DEVELOPMENT/ PLAN REVIEW APPLICATION

TO: John Griego FAX #: 438-0028
FROM: Russell Brito Contact Phone #: 924-3337
RE: **Site Development Plan for Building Permit Deficiencies**
Project Description: Family Worship Center
EPC Project #: 1000694 EPC Case #: 03EPC-01111

TO: SHERAN MATSON, DRB CHAIR
FROM: MARY PISCITELLI, STAFF PLANNER
SUBJECT: FAMILY WORSHIP CENTER, PROJECT #1000694
DATE: 11/26/03
CC: JOHN GRIEGO, JCG ARCHITECTS

JOHN GRIEGO agent for FAMILY WORSHIP CENTER request the above action for all or a portion of Lot 226, 227 228, 229 and 230 **Town of Atrisco Grant -Airport Unit**, zoned SU-1 Church, located on GLENRIO NW, between 72ND ST. NW and I-40, containing approximately 8 acre(s). (J-10) Mary Piscitelli, Staff Planner

DATE	BY	CHKD
08-12-03	JG	JG
SHEET TITLE DRAINAGE PLAN SCALE 1" = 40'-0" 2 OF 7 C1.3 WR JG

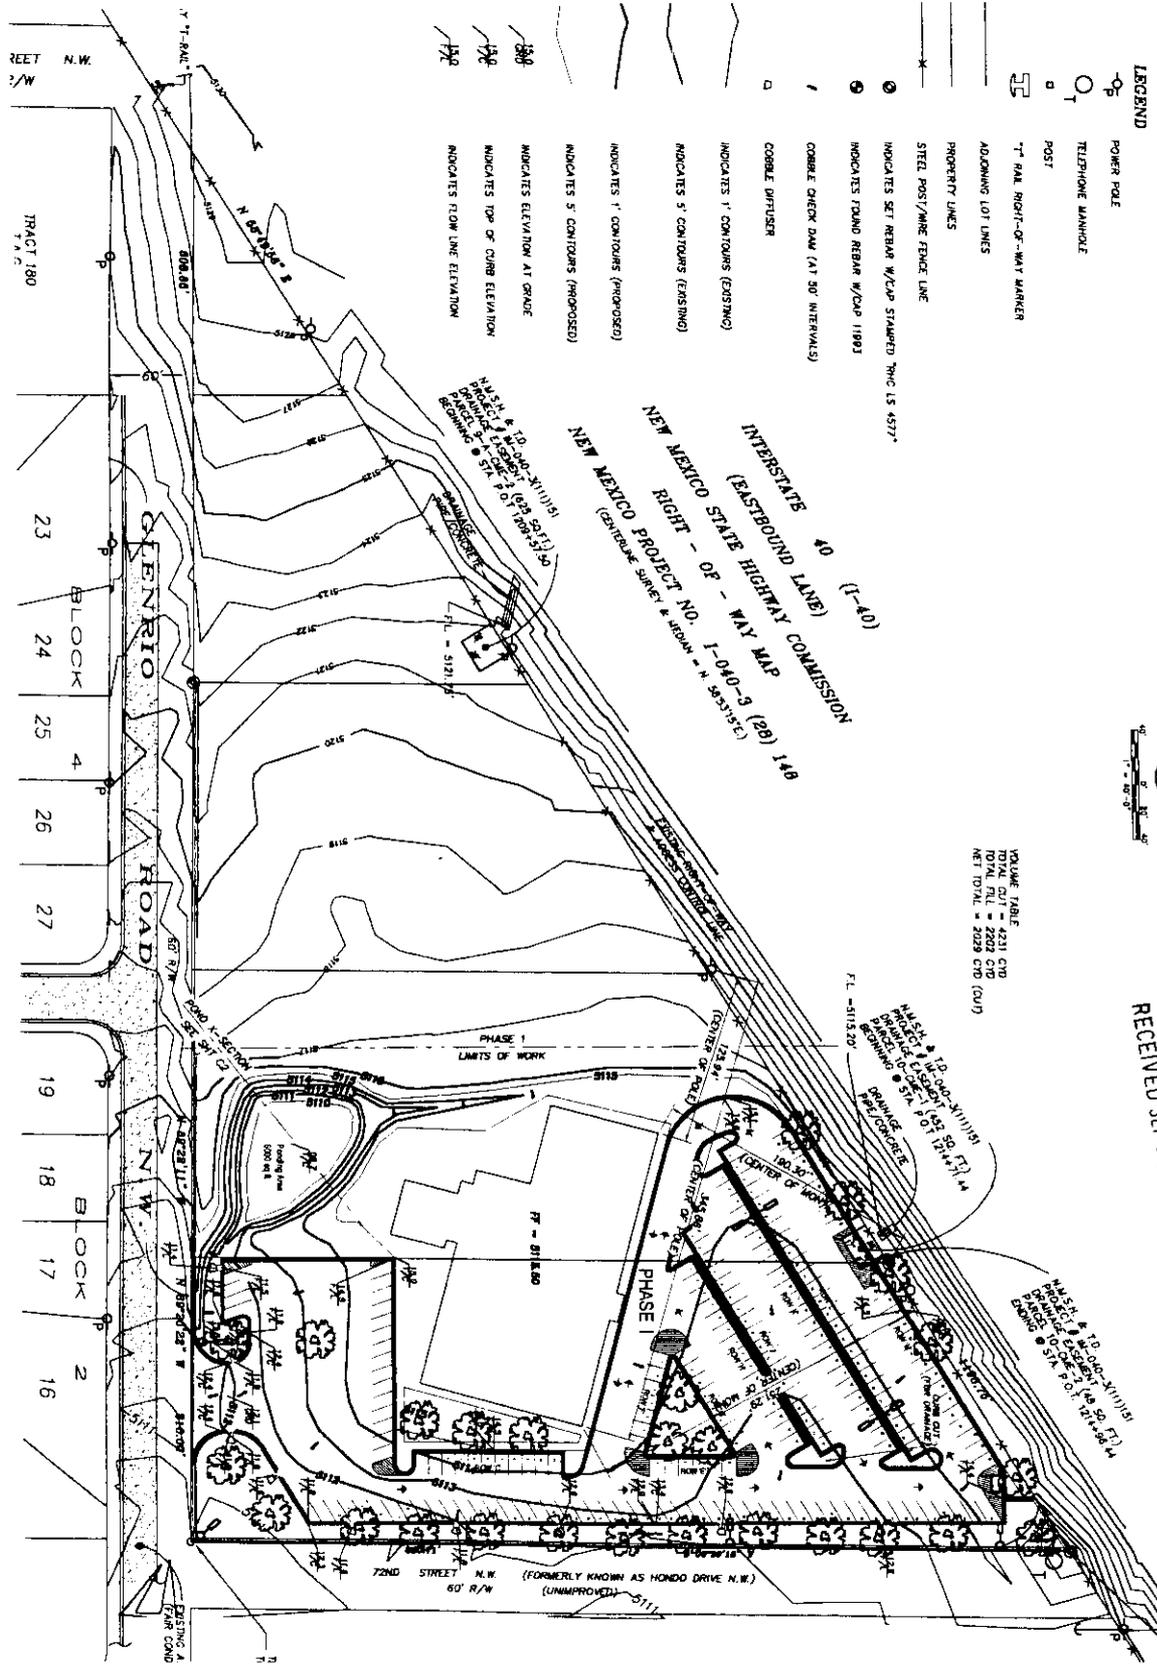
-
- k. Site plan on sheet C1.2 should match sheet C1.3 (i.e. parking lot layout).
 - l. Fire protection requirements including instantaneous flow and hydrant placement must be verified with the Fire Marshals office and Utility Development before site plan sign off at DRB.
7. As per Solid Waste Management Department Comments: Approved on condition, will coordinate with SWMD on enclosure requirements and ordinances.
 8. As per the Fire Marshall's Office:

Sheet 2 – C-1.3 SITE DRAINAGE PLAN

- SITE GRADING NARRATIVE
- PARKING REVISED TO COMPORT WITH C-1.2

DATE	11-10	BY	MS
SCALE	1" = 40'-0"		
SHEET TITLE	SITE UTILITY PLAN		
NO.	3	OF	7
PROJECT	C1.7

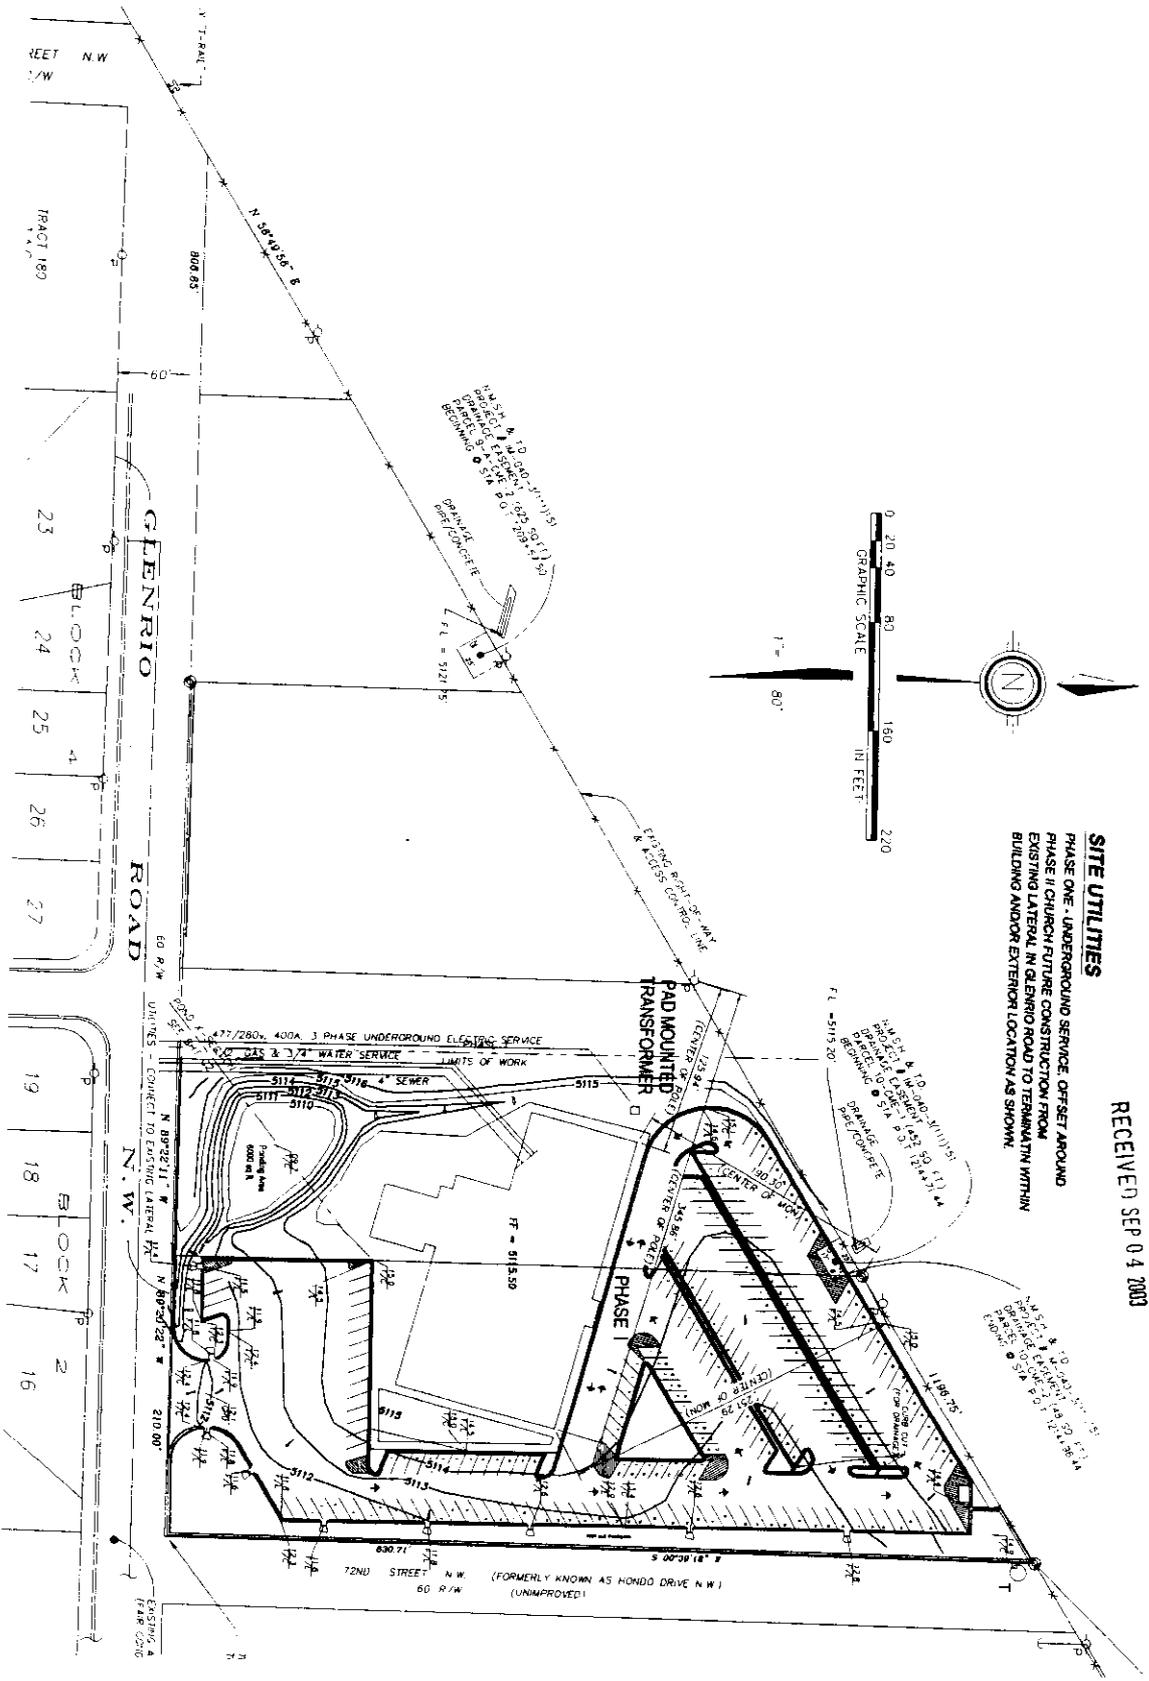
- p. L-1 and p. C-7. The landscape plan and the utilities plan for Phase One are not consistent with the Phase One site plan (p. C-5), specifically, the parking configuration on the site plan is different. The parking on the site plan is the approved parking configuration. The EPC placed a condition that the site plan shall be corrected for parking, drive aisles, landscape elements, and building footprint.. All plans (site, utilities, grading and drainage, landscape, etc) shall be consistent with the approved site plan. The plans will need to be closely checked with the site plan as the base plan for all other plans.

LANDSCAPE PLAN

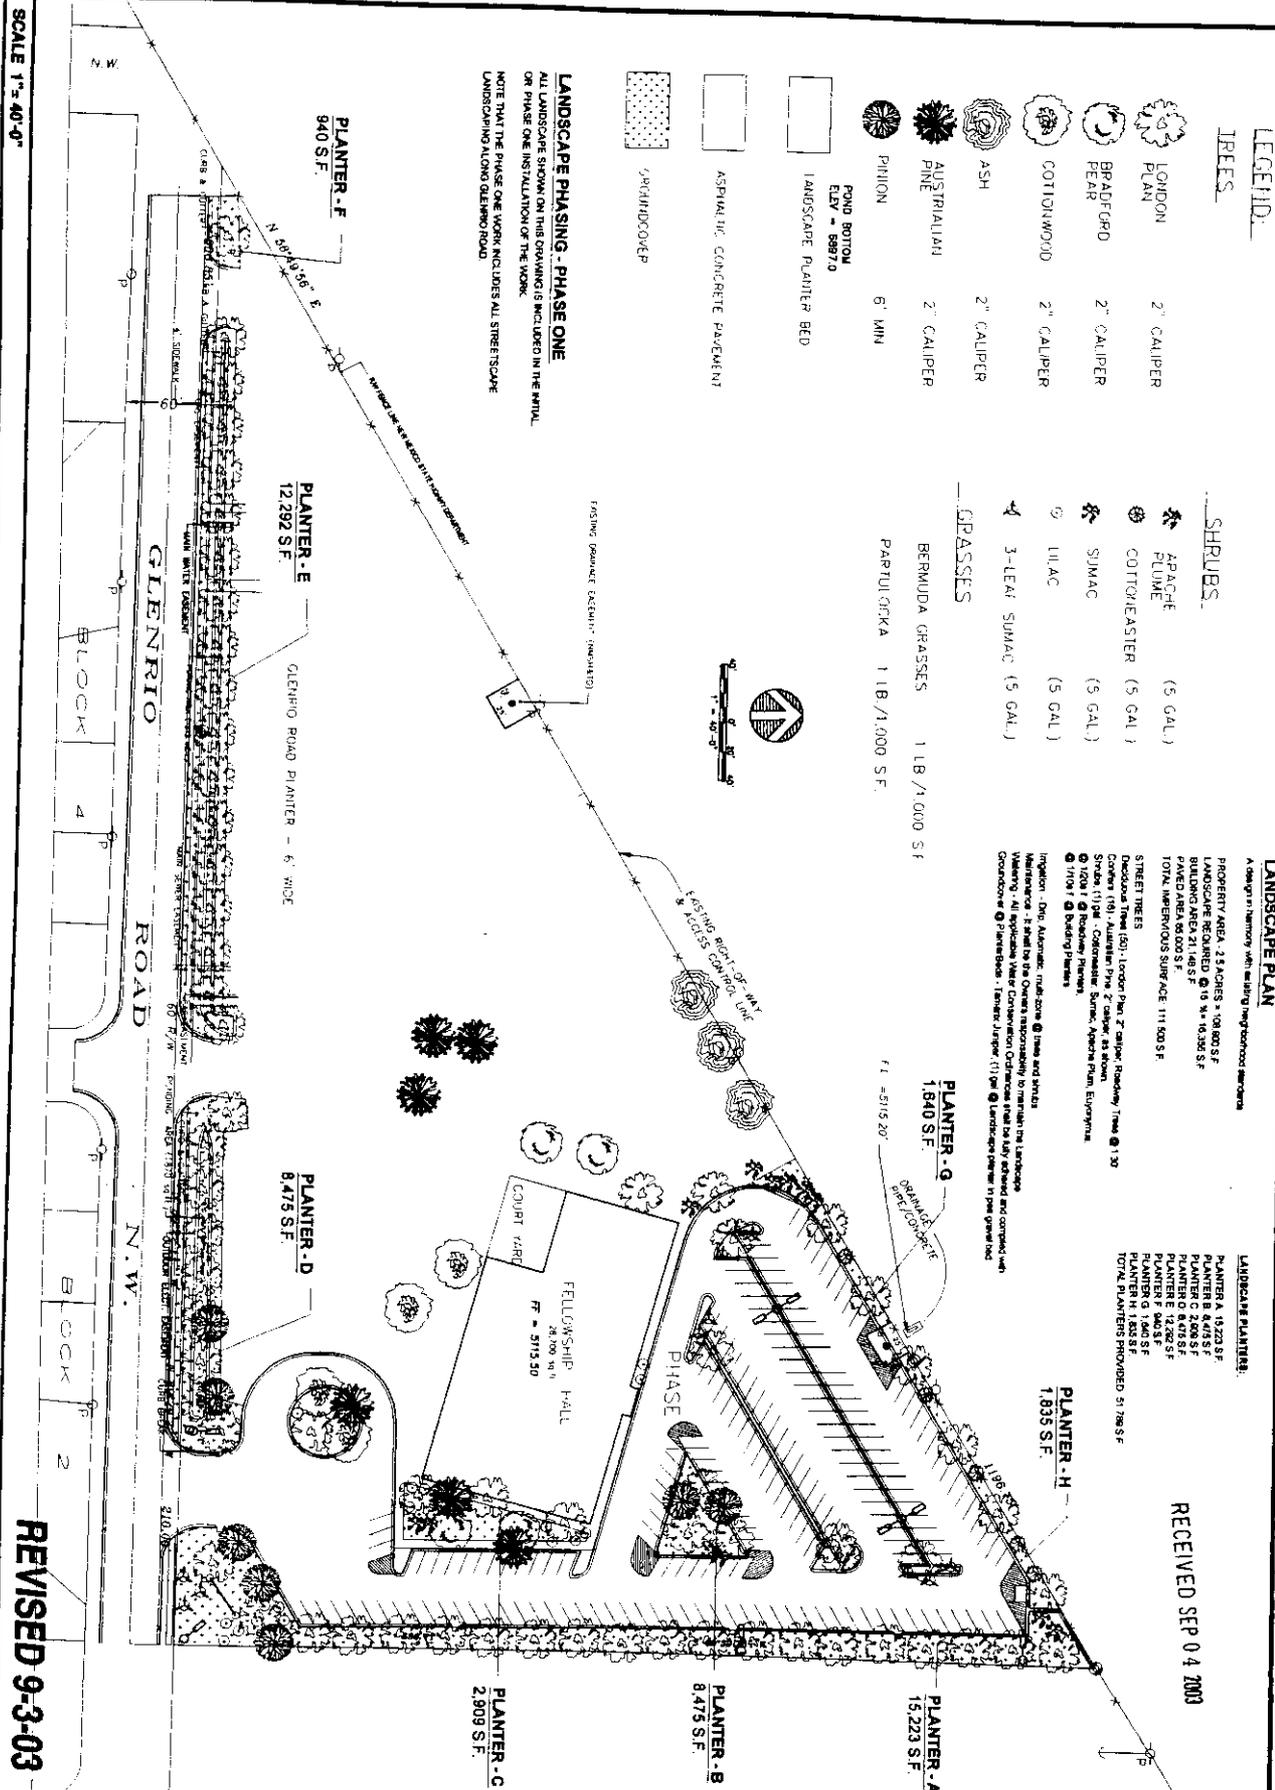
- p. L-1. The landscape plan shows the building area as 21,148 sf. The master plan for the site shows the same building area as 28,000 sf. This discrepancy will need to be addressed, because their landscaping calculations are affected by the difference of approximately 7000 sf of building.

REVISED 9-3-03
 SITE DRAINAGE PLAN

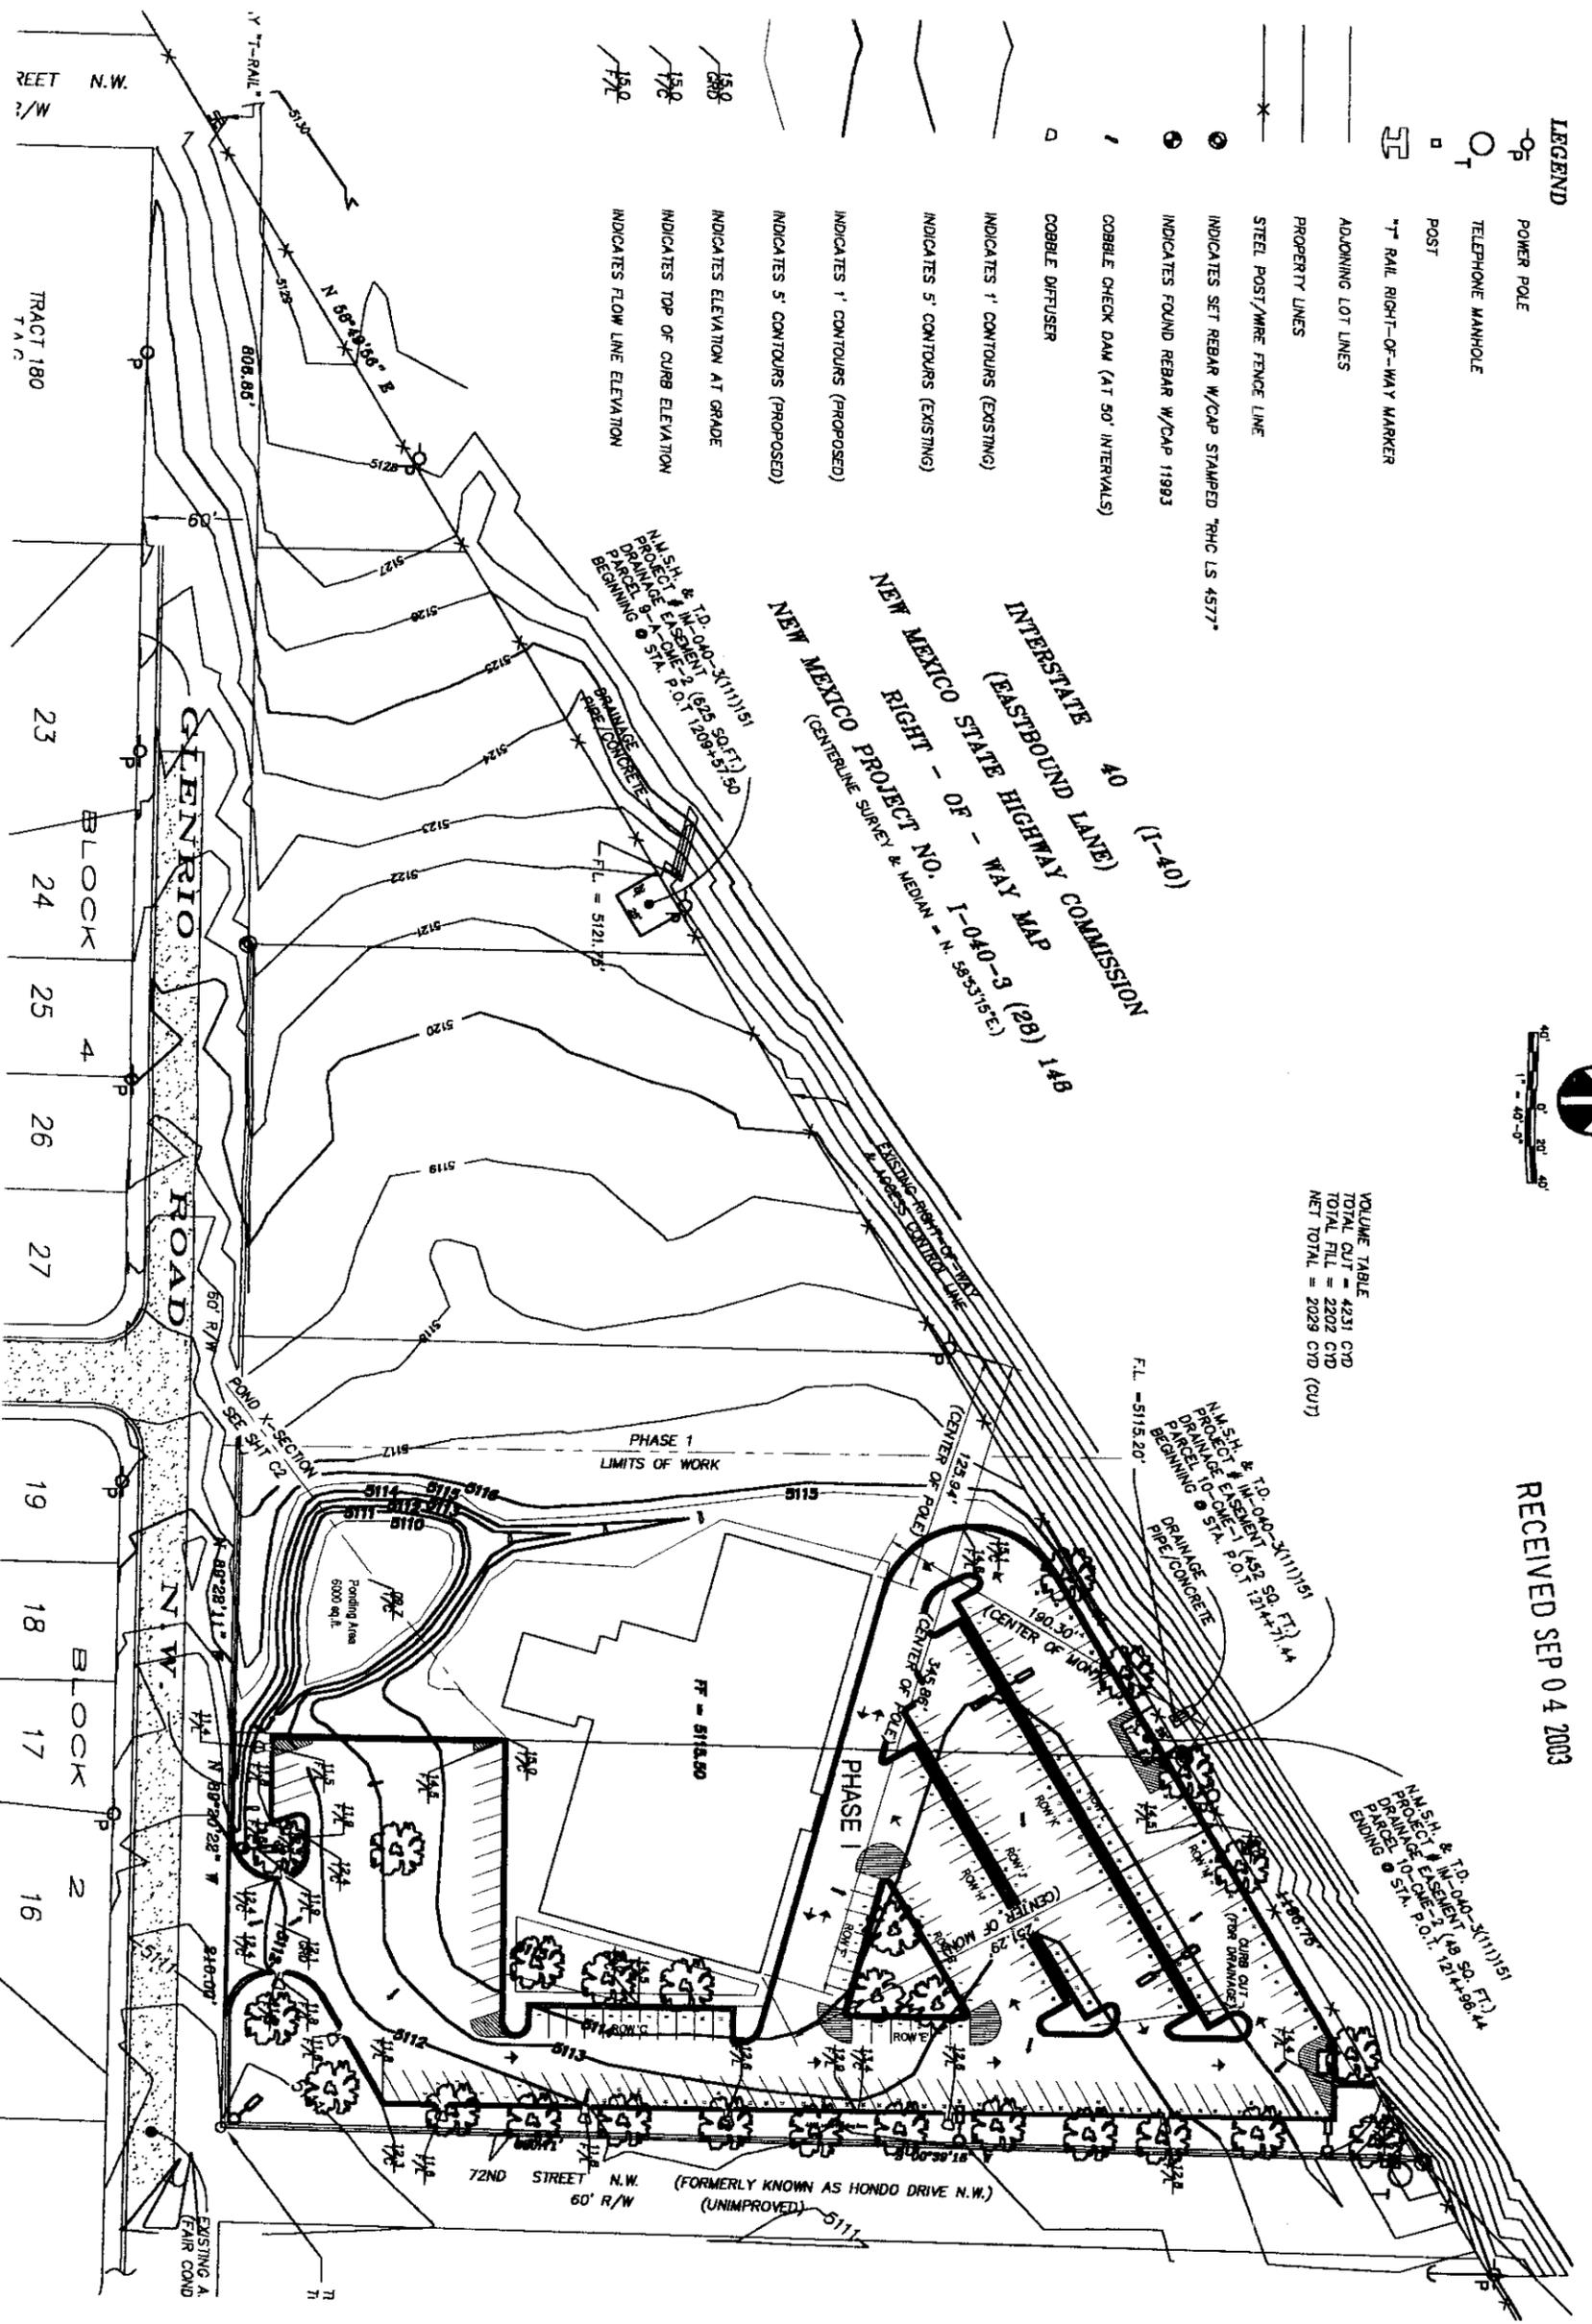
- Site plan on sheet C1.2 should match sheet C1.3 (i.e. parking lot layout).

Sheet 2 – C-1.3 SITE DRAINAGE PLAN

- SITE GRADING NARRATIVE
- PARKING REVISED TO COMPORT WITH C-1.2
